Seneca Army Depot Activity  
Romulus, New York

# Final Work Plan for the PFAS Expanded Site Investigation, SEAD 25 and SEAD 26, Seneca Army Depot Activity

Contract No. W912DY-09-D-0062  
Task Order No. 0023  
EPA SITE ID# NY0213820830  
NY Site ID# 8-50-006

February 2019

**FIGURE 2**  
SEAD-25 Proposed Primary Well Locations

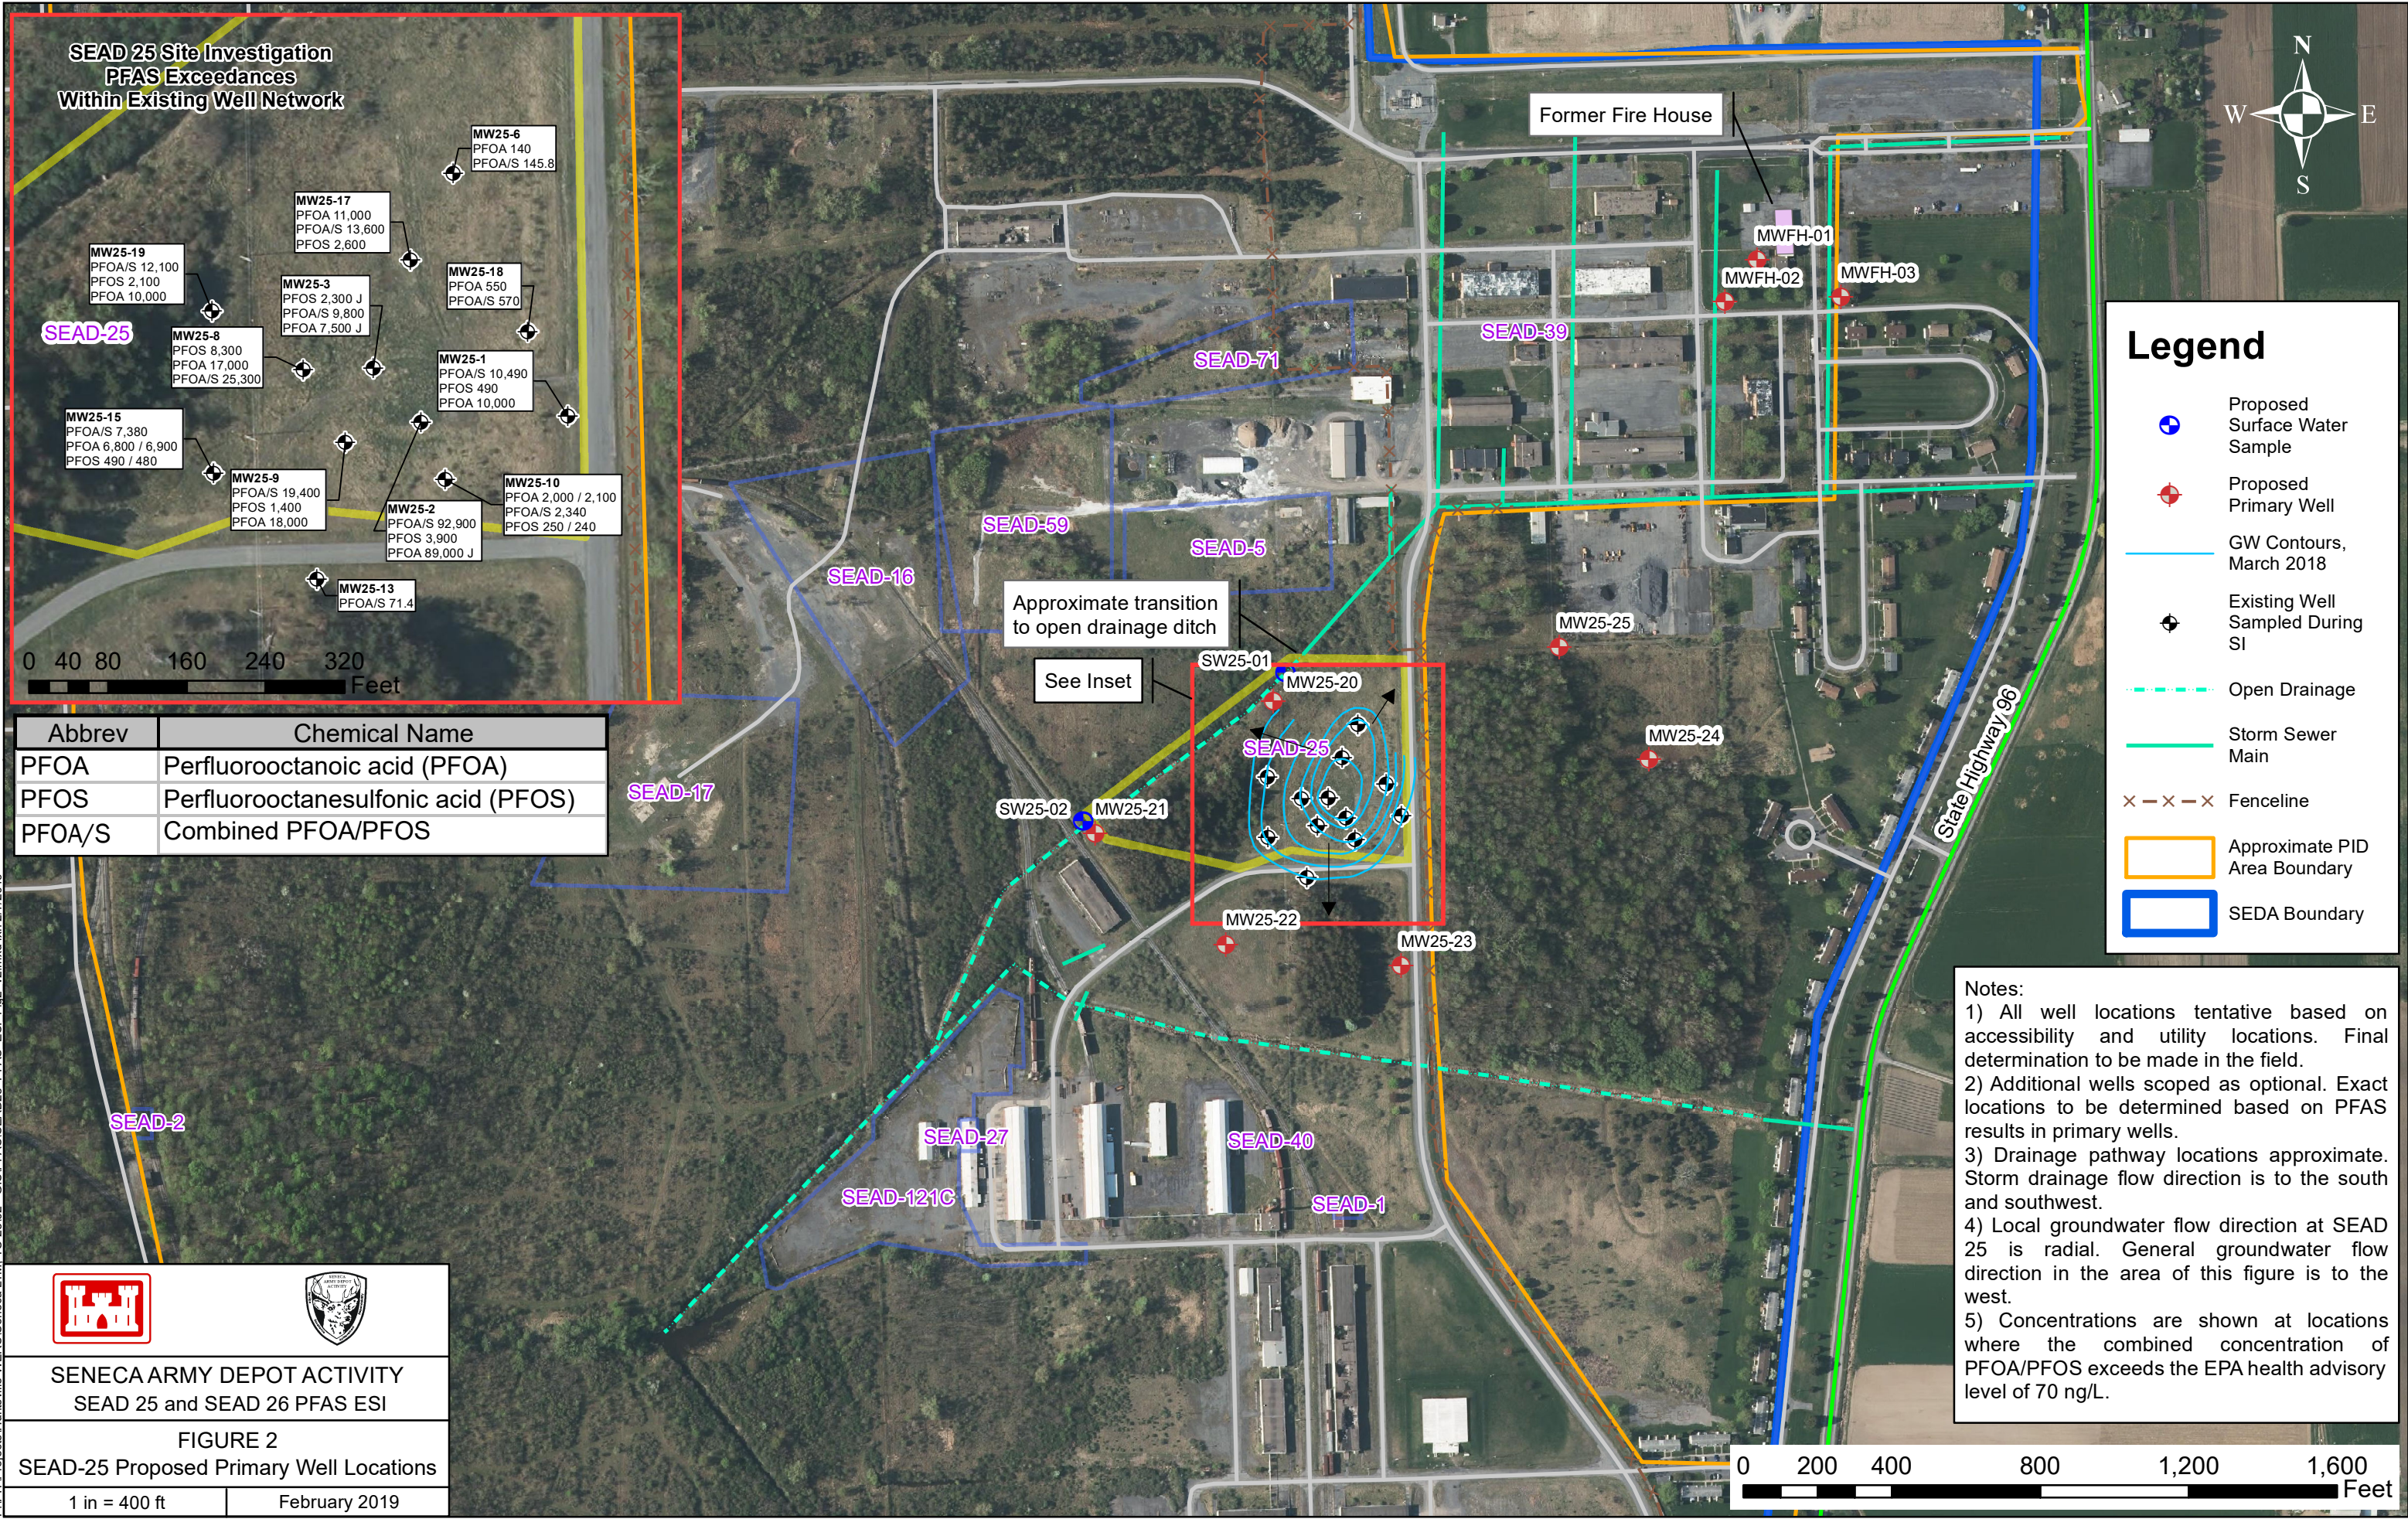
**Comment 4:** Figure 2 depicts gw contours and the proposed well locations. Suggest installing two (2) additional wells in the E-SE quadrant since the gw flow is radial around MW25-2 (which contains the highest concentrations of PFAS) and gw contours appear to have a steep gradient towards the E-SE direction.
